ADDENDUM #1 to

Resetting Granite Tree Pit Pavers

Great Rivers Greenway and National Park Service

Addendum #1 – Included Add-alternate: resetting walkway pavers – See Page 3, #8.

6 GRANITE PAVERS @ PROCESSIONAL WALKS EDGE SECTION SCALE (B) C# 1, 2, 3

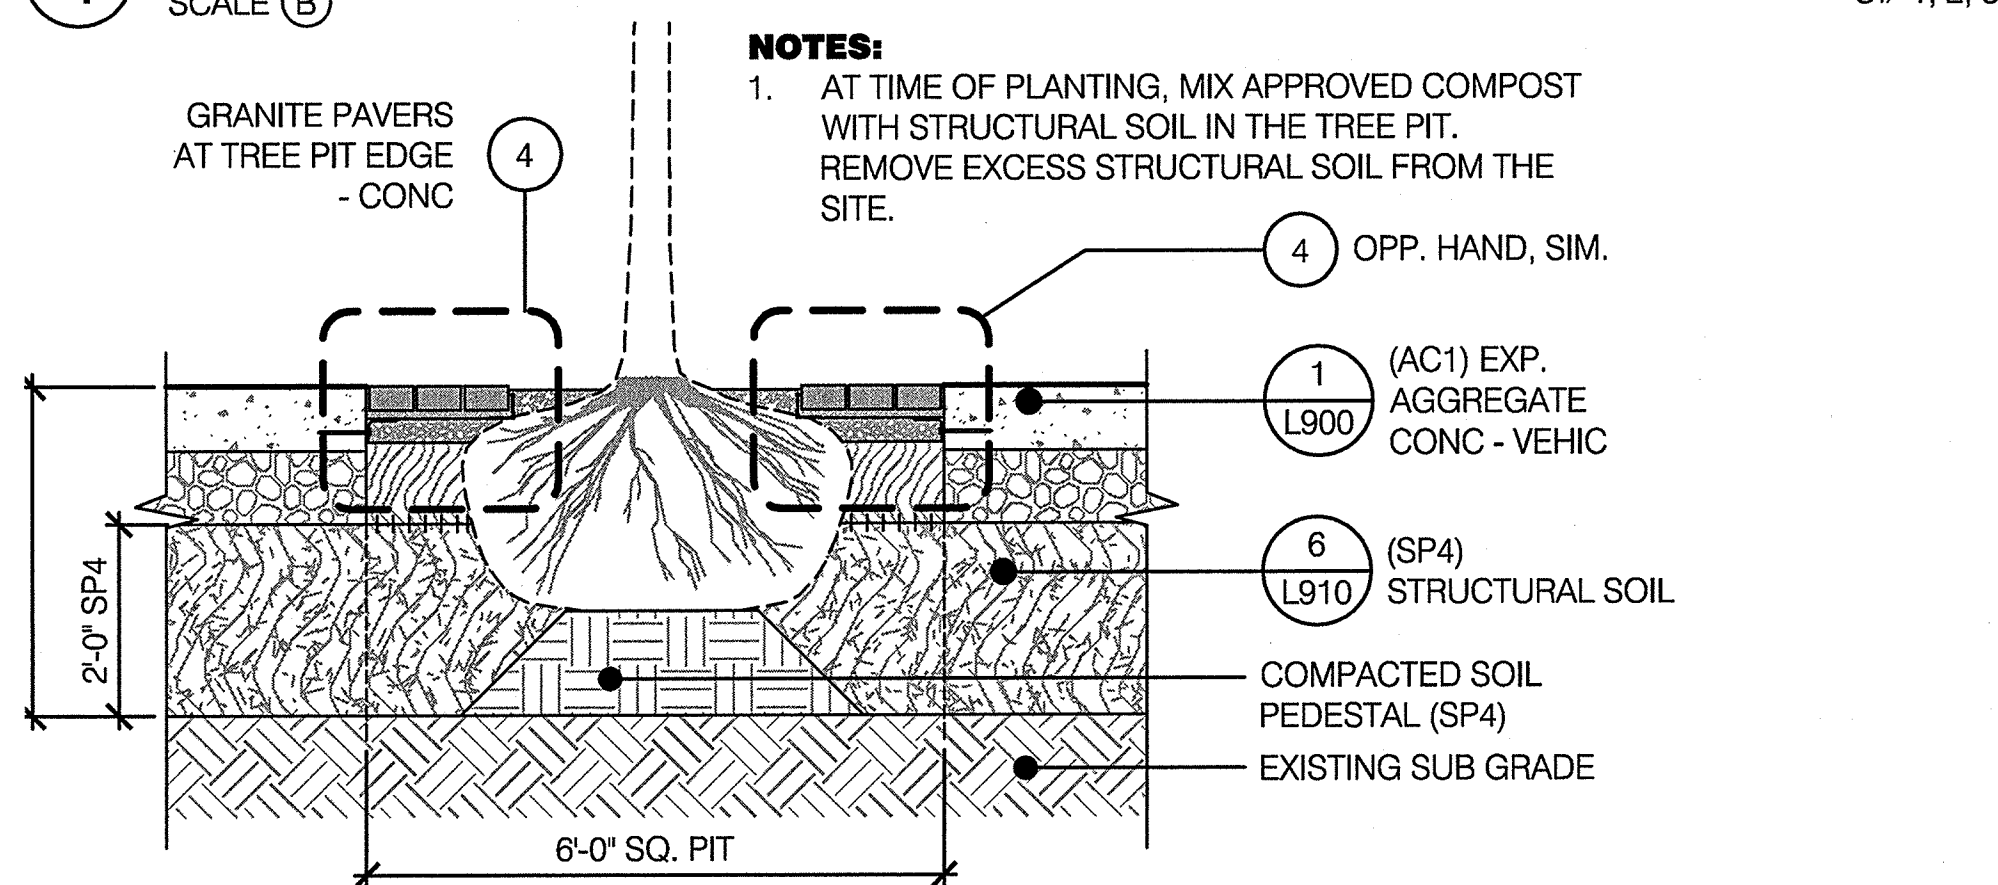
7. General Description: To reset granite pavers around tree planting pits on the National Park Service Gateway Arch National Park in St. Louis, Missouri. Scope of work and diagrams are provided in **EXHIBITS A, B and C**.
8. ADDENDUM #1 – Add-alternate bid for resetting walkway pavers. Walkway pavers have settled to a lesser extent and the District will accept a unit price per linear foot to reset the walkway edge pavers per the same specifications listed for tree pit pavers.
